Product Change Notice (PCN)

PCN Number: PCN-0454746R-01

Product(s) Affected: SJ2-25102B-SMT-TR, SJ2-25103A-SMT-TR

PREVIOUS CUI DEVICES DETAIL / IMAGE	NEW CUI DEVICES DETAIL / IMAGE

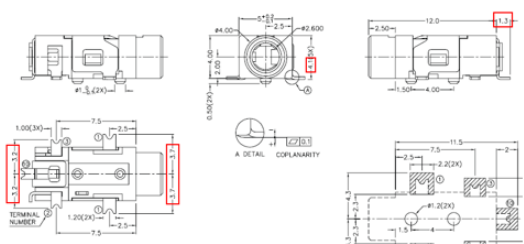
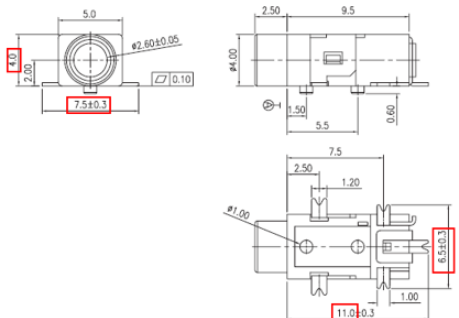
Description of Change: *Mechanical, material, soldering, and packaging changes as shown below:*

<p style="text-align: center;">Recommended PCB Layout Top View</p>	 <p style="text-align: center;">Recommended PCB Layout Top View</p>																																				
<table border="1"> <thead> <tr> <th></th> <th>MATERIAL</th> <th>PLATING</th> </tr> </thead> <tbody> <tr> <td>terminal 1</td> <td>copper alloy</td> <td>silver</td> </tr> <tr> <td>terminal 2</td> <td>copper alloy</td> <td>silver</td> </tr> <tr> <td>terminal 3</td> <td>copper alloy</td> <td>silver</td> </tr> <tr> <td>terminal 10</td> <td>copper alloy</td> <td>silver</td> </tr> <tr> <td>plastic</td> <td>PA10T</td> <td></td> </tr> </tbody> </table>		MATERIAL	PLATING	terminal 1	copper alloy	silver	terminal 2	copper alloy	silver	terminal 3	copper alloy	silver	terminal 10	copper alloy	silver	plastic	PA10T		<table border="1"> <thead> <tr> <th>DESCRIPTION</th> <th>MATERIAL</th> <th>PLATING/COLOR</th> </tr> </thead> <tbody> <tr> <td>terminal 1</td> <td>C5210 t=0.25</td> <td>gold flash over nickel</td> </tr> <tr> <td>terminal 2</td> <td>C5210 t=0.25</td> <td>gold flash over nickel</td> </tr> <tr> <td>terminal 3</td> <td>C5210 t=0.25</td> <td>gold flash over nickel</td> </tr> <tr> <td>terminal 10</td> <td>C2680 t=0.25</td> <td>gold flash over nickel</td> </tr> <tr> <td>housing</td> <td>PA10T (UL94V-0)</td> <td>black</td> </tr> </tbody> </table>	DESCRIPTION	MATERIAL	PLATING/COLOR	terminal 1	C5210 t=0.25	gold flash over nickel	terminal 2	C5210 t=0.25	gold flash over nickel	terminal 3	C5210 t=0.25	gold flash over nickel	terminal 10	C2680 t=0.25	gold flash over nickel	housing	PA10T (UL94V-0)	black

MATERIAL	PLATING																																			
terminal 1	copper alloy	silver																																			
terminal 2	copper alloy	silver																																			
terminal 3	copper alloy	silver																																			
terminal 10	copper alloy	silver																																			
plastic	PA10T																																				
DESCRIPTION	MATERIAL	PLATING/COLOR																																			
terminal 1	C5210 t=0.25	gold flash over nickel																																			
terminal 2	C5210 t=0.25	gold flash over nickel																																			
terminal 3	C5210 t=0.25	gold flash over nickel																																			
terminal 10	C2680 t=0.25	gold flash over nickel																																			
housing	PA10T (UL94V-0)	black
